MONTGOMERY COUNTY PLANNING DEPARTMENT

MEMORANDUM

REVIEW TYPE: Site Plan and Final Water Quality Plan Review
CASE #: 820050380
PROJECT NAME: Eastside
APPLYING FOR: Approval of 265 dwelling units on 23.82 acres
REVIEW BASIS: Div. 59-D-3 of Montgomery County Zoning Ordinance

STAFF RECOMMENDATION: Approval of the Final Water Quality Plan and 265 dwelling units, including 34 MPDUs, on 23.82 acres. All site development elements as shown on Eastside Site Plans stamped by the M-NCPPC on January 25, 2007, shall be required except as modified by the following conditions:

Figure 4 - Site Plan

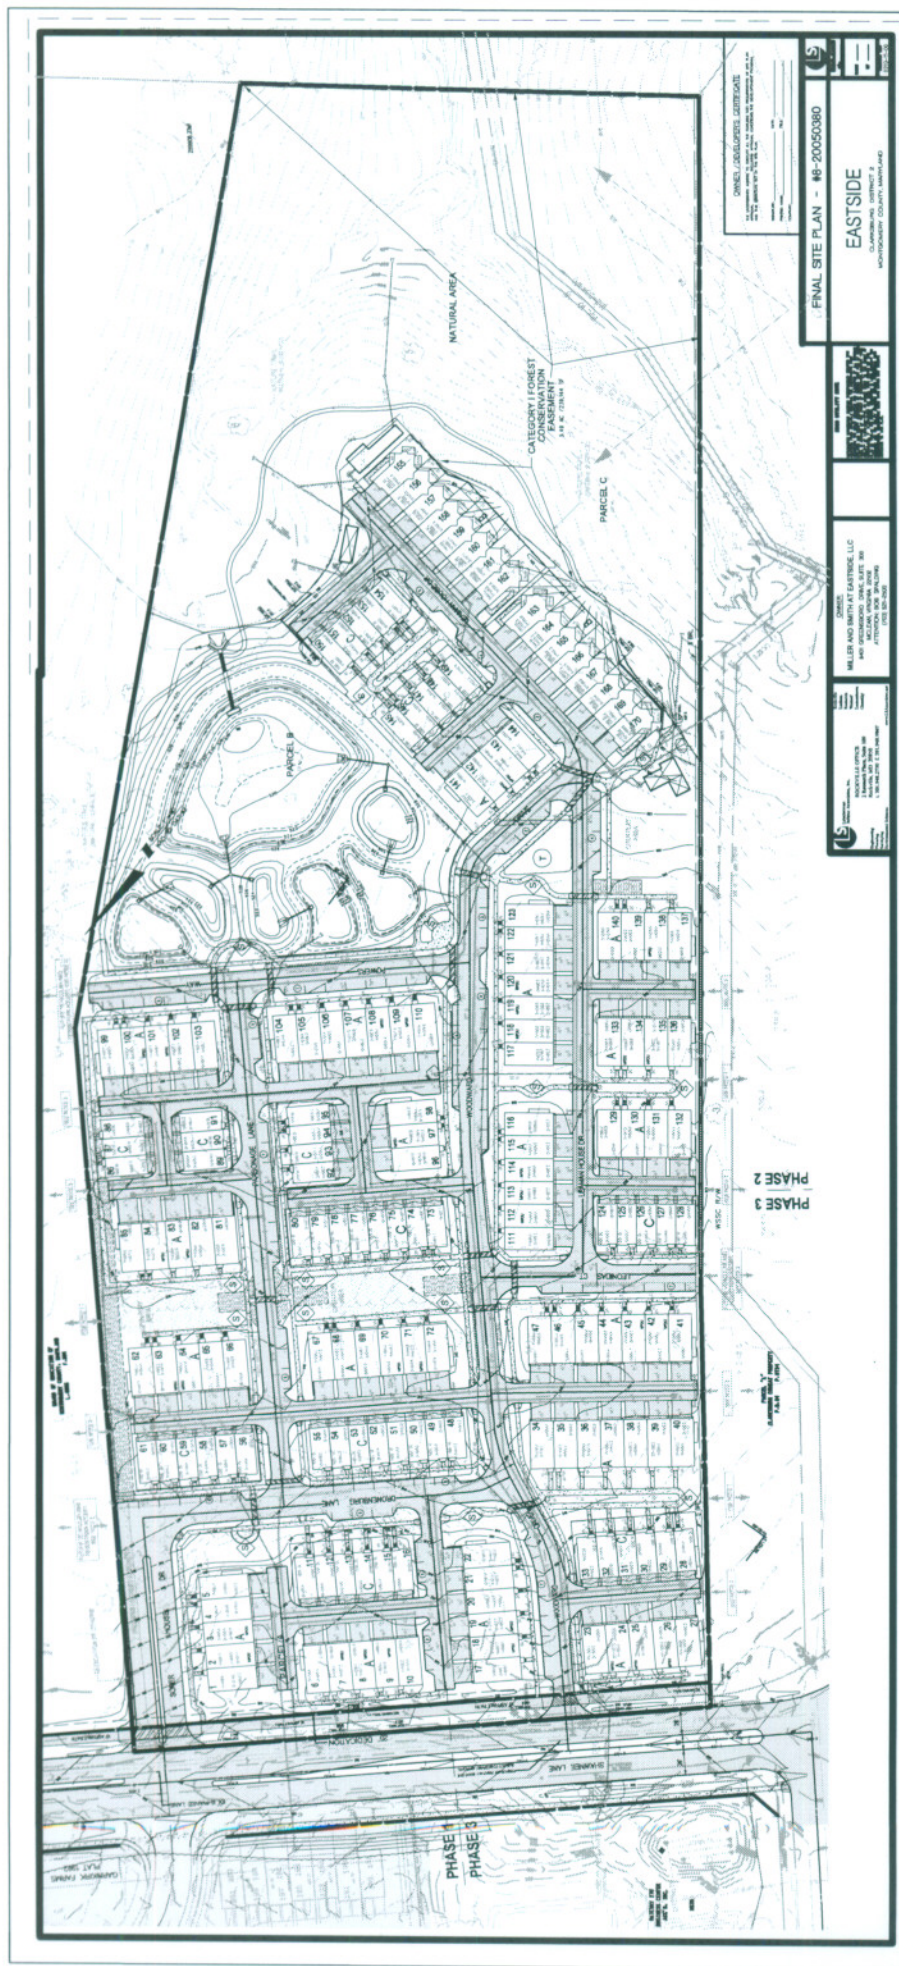
The proposed site plan (Figure 4) contains 265 units, 20 fewer than in the approved Preliminary Plan. Seventy-five units (75) are townhouses; 190 are two-over-two multi-family units. Thirty-four of the multi-family units are Moderately Priced Units (MPDUs). The MPDUs are dispersed throughout the development and located in the first floor unit of designated buildings.

Staff notes that the mix of units in the proposed plan is different from that shown in the preliminary plan. In both the preliminary plan and zoning case, the mix of units was 80% multi-family and 20% attached. The deletion of 20 lots and rearranging unit types results in a loss of 36 multi-family units and an increase of 16 townhouses, for a final mix of 74% multi-family and 26% townhouses. The mix of units was an issue for the community and the Community-Based Planning Division at the time of the preliminary plan. The revisions address that concern.

The layout of the units consistently reinforces the differentiation between public and private spaces in a dense development. Each unit faces public spaces and private spaces and parking for each unit is provided at the rear. There are smaller groups of units within the overall plan and each group has open space for community interaction. The layout provides adequate space between and around units. All units are setback from the property boundary at least 5 feet. Townhouse units have front and rear setbacks from the individual lot. The rears of the condominium multi-family units are setback at least 20 feet from the alleys to accommodate on-site parking. There is a distance of at least 10 feet between the multifamily units. Staff finds that the overall layout is adequate, safe and efficient.

Figure 5 - Applicant's Exhibit
Additional Green Space

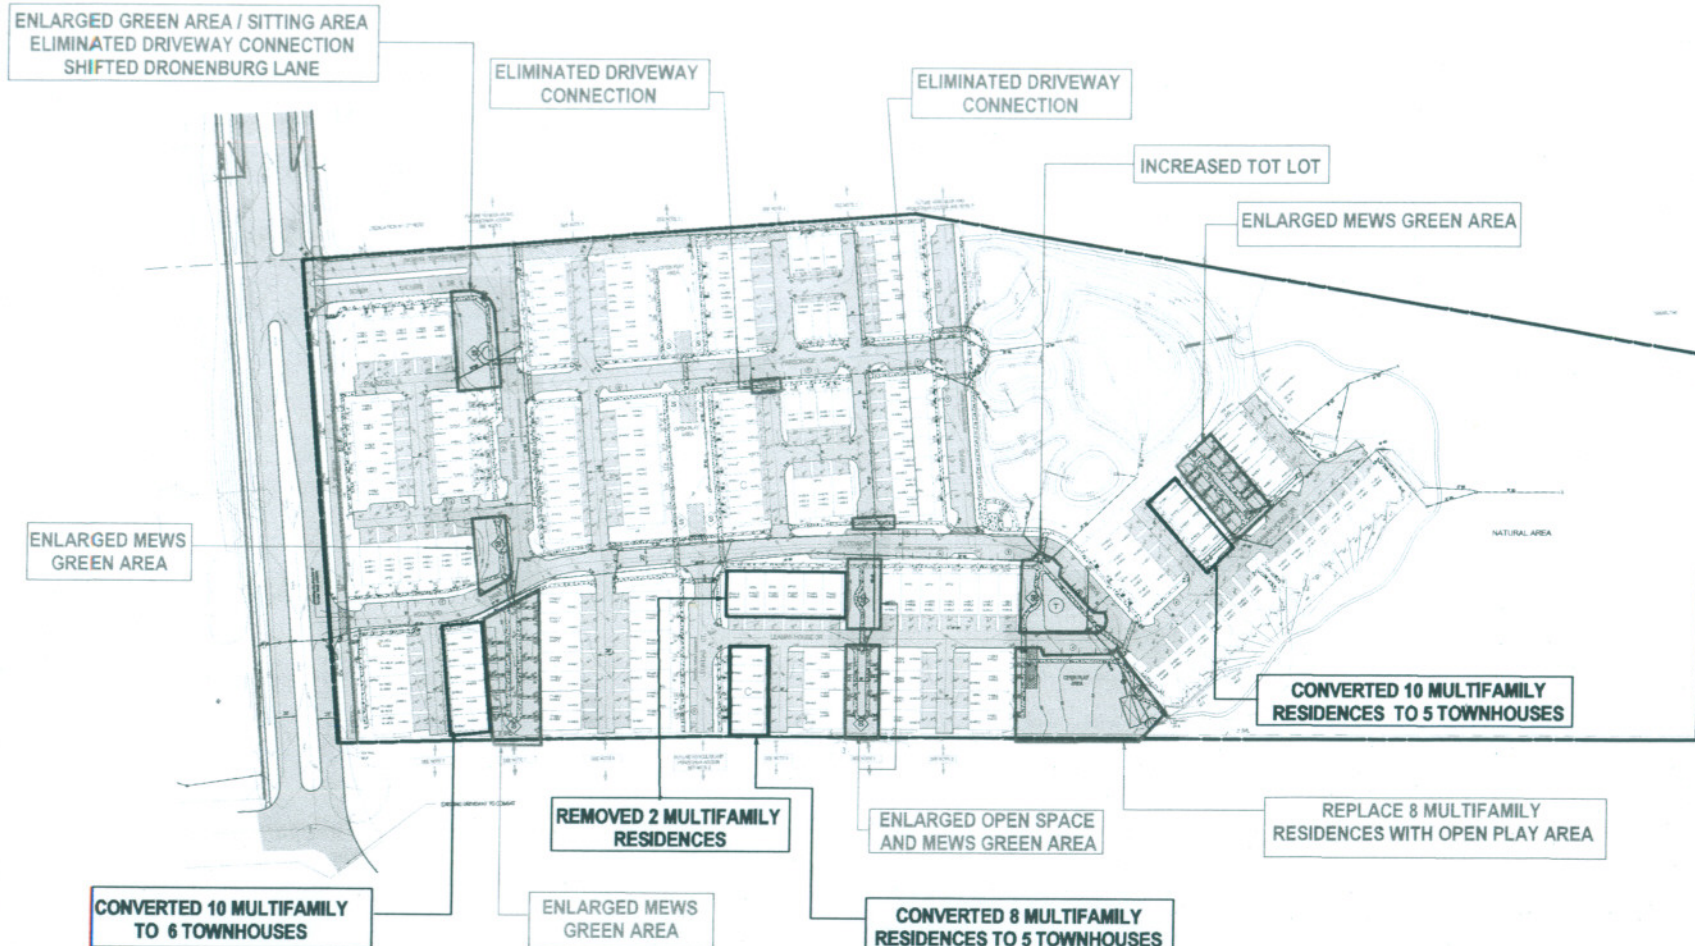
The revised plan shows 4 more townhouses (Lots 145-149) with access only to an alley. A waiver from the frontage requirements of Section 50-29 (a) (2) is necessary for these units. If the Board approves the waiver, a total of 8 townhouses would be waived from the requirements of Chapter 50-29 (a) (2).

The applicant has provided an exhibit, Figure 5, depicting the layout revisions. The proposed site plan is an improvement to that shown at subdivision. The revisions reduce the number of units, provided additional green space and usable common space and reduce the number of multi-family units.

FIRE MARSHAL COMMENTS

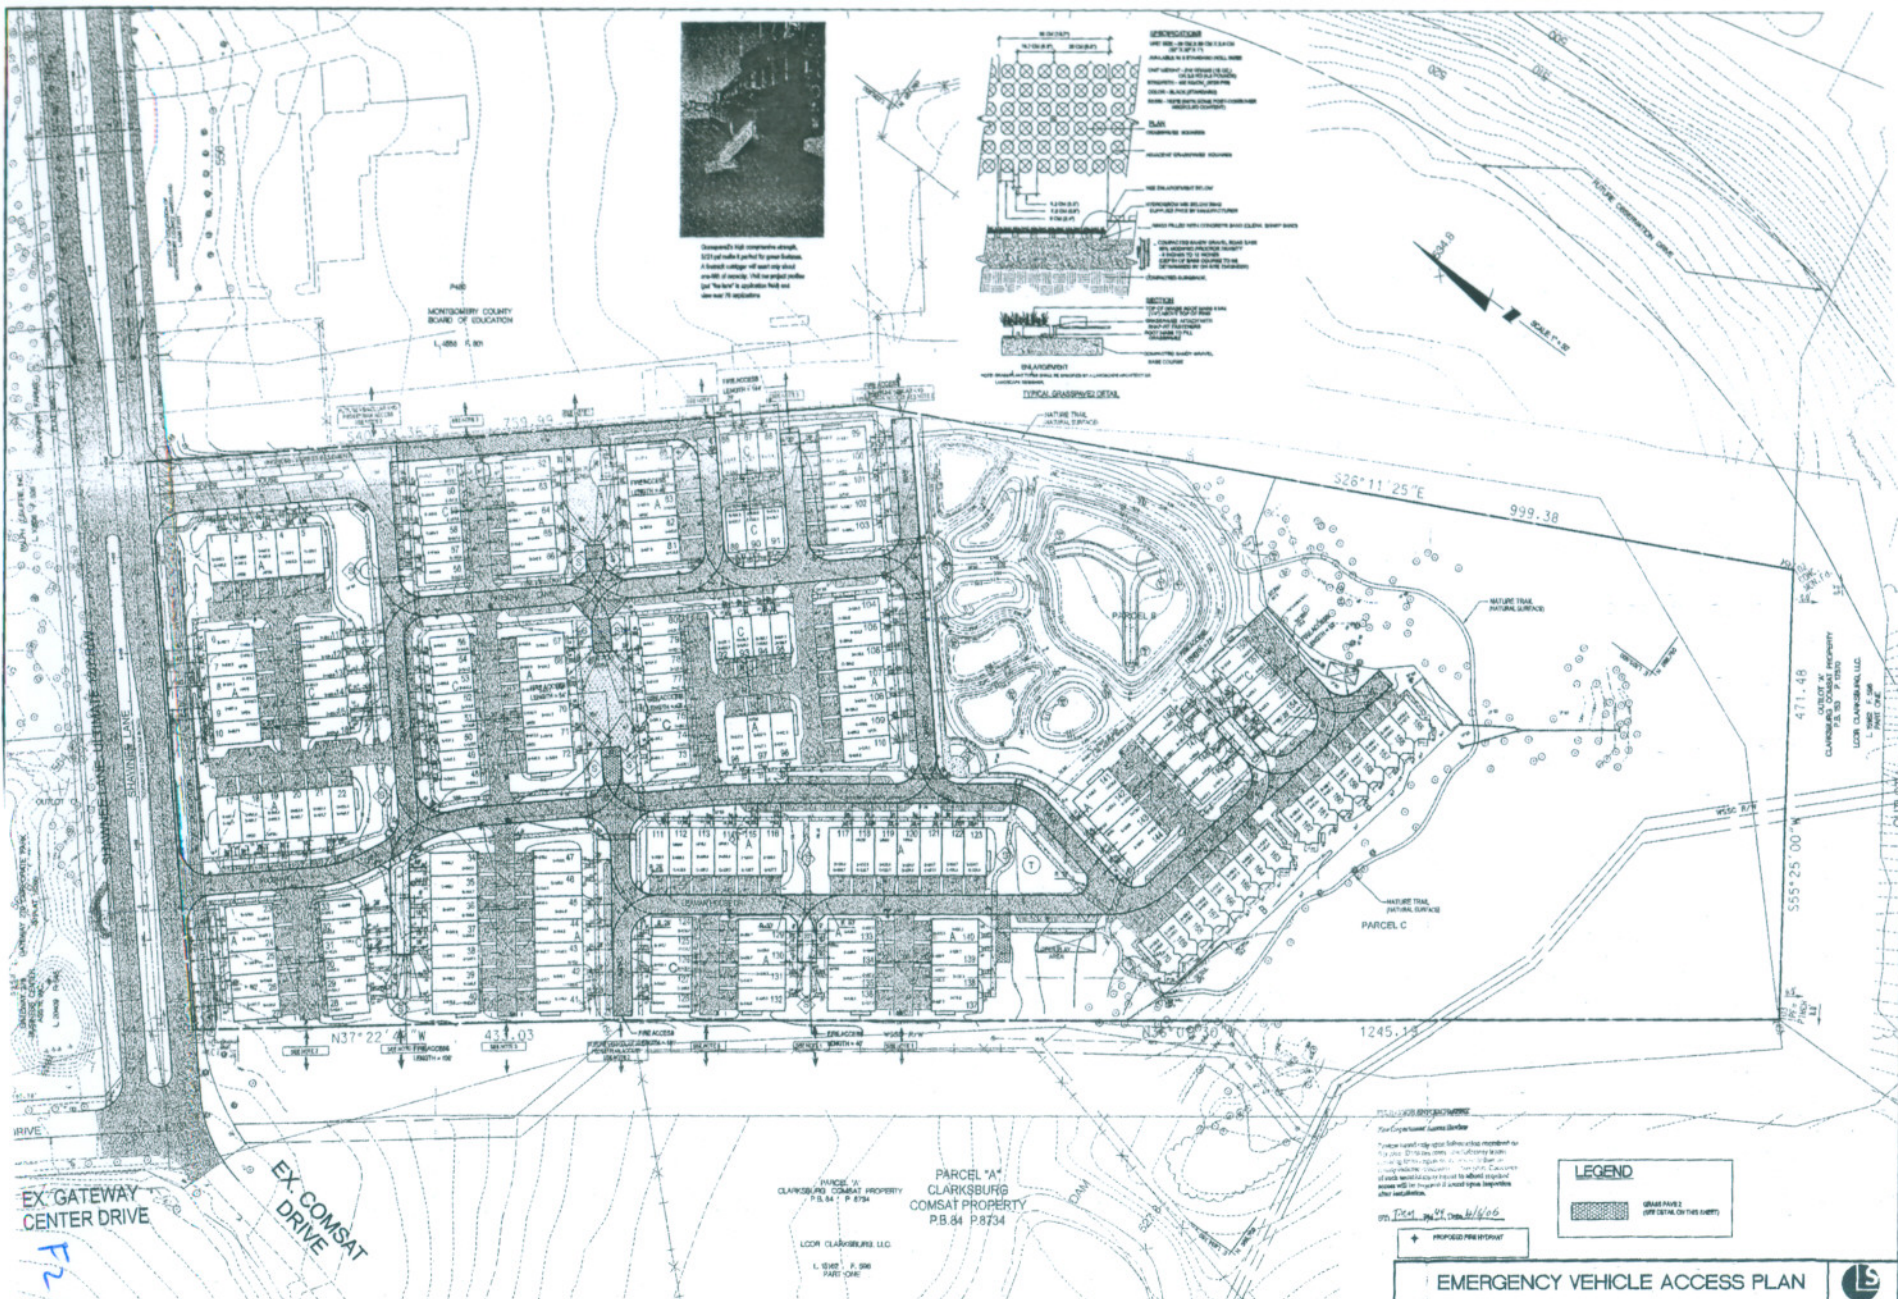
PLAN APPROVED provided the following conditions are met:

1. A traffic order establishing a fire lane must be in place prior to occupancy of any part of this community.
-
1. Review based only upon information contained on the plan submitted 9-26-06. Review and approval does not cover unsatisfactory installation resulting from errors, omissions, or failure to clearly indicate conditions on this plan.
 2. Correction of unsatisfactory installation will be required upon inspection and service of notice of violation to a party responsible for the property.
